## Demolition of 37 Bancroft is not justified

# College Wellbeing Centre (SSD-9912)

Recommendation from the  
Department of Planning,  
Industry and Environment to  
the Independent Planning  
Commission NSW

### **An Acoustic Barrier (2-3m high)**

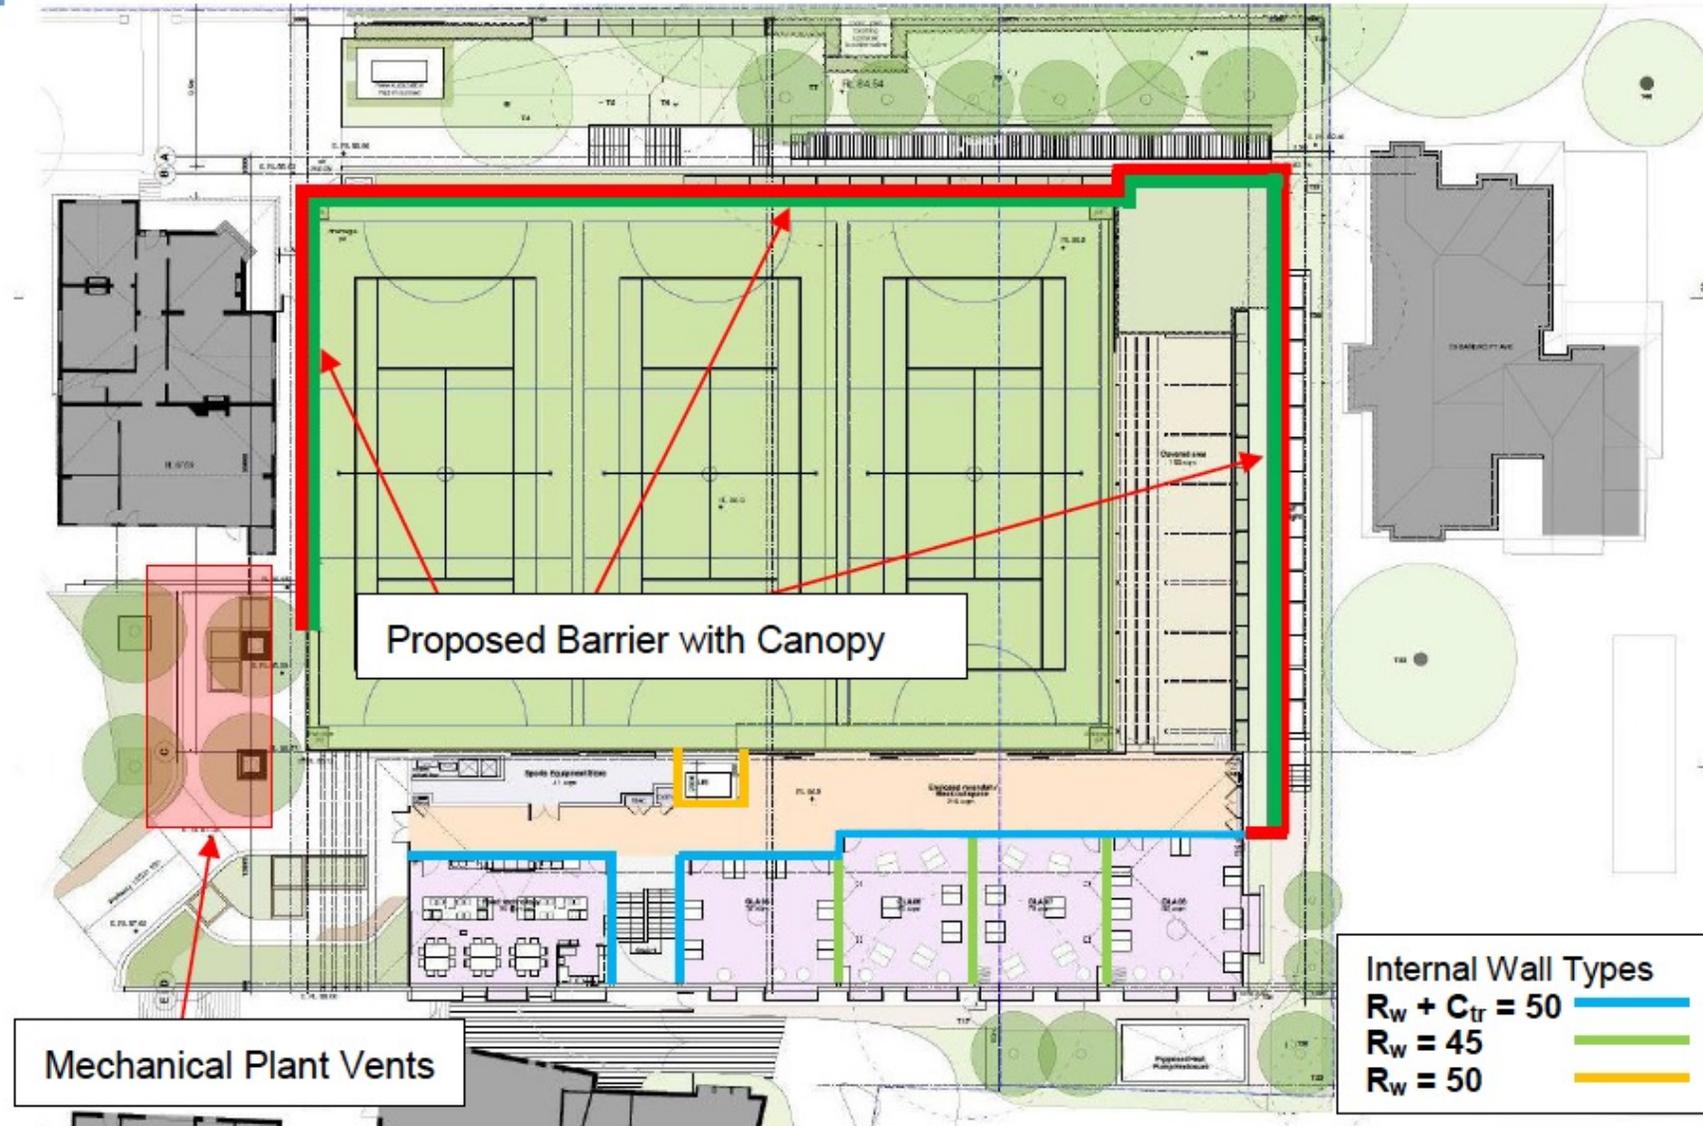
*This barrier will dramatically change the appearance of the proposed building.*

- **not shown in any illustrations or perspectives**
- **not mentioned in the Heritage Impact Statement**

**N.B. Perspective does not show 3 metre high solid acoustic barrier behind tennis court mesh.**

*A 2 metre high noise barrier with 1 metre high cantilevered canopy (or 3 metre high noise barrier) should be constructed along the northern and north-western boundary (to Bancroft Avenue) and the eastern boundary adjacent to the covered area (to 39 Bancroft Avenue);*

*The acoustic barrier must contain no gaps along the surface area, and be constructed from the floor of the sports area to a height of 3 metres (to prevent the transmission of noise below the barrier);*
